### 1 Products affected

### 2 Type of change

Product Change Notification					PCN KM		D10-017-319
owner	creation date	release date	released by	change order no	rev	page	
bachmajo	11.07.2017	13.09.2017	buerglal	2013177	A	1 of 2

Old label without configuration code	New label with configuration code

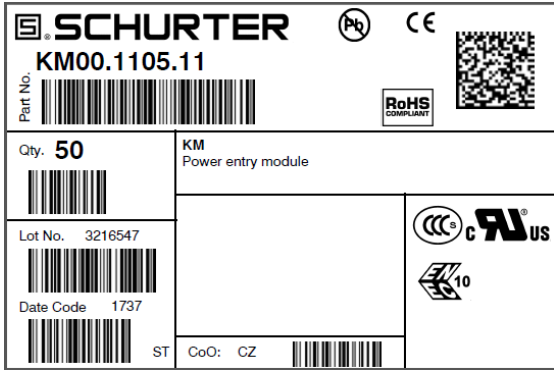
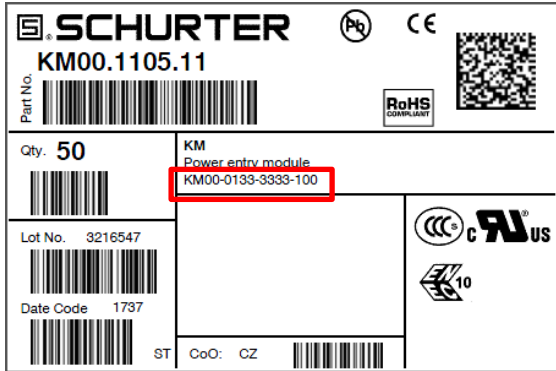
Change of plastic material from PET to PA6 (Socket)  
 Change of plastic material from PBT to PA66/6 (Cover)  
 Inclusion of configuration code on label
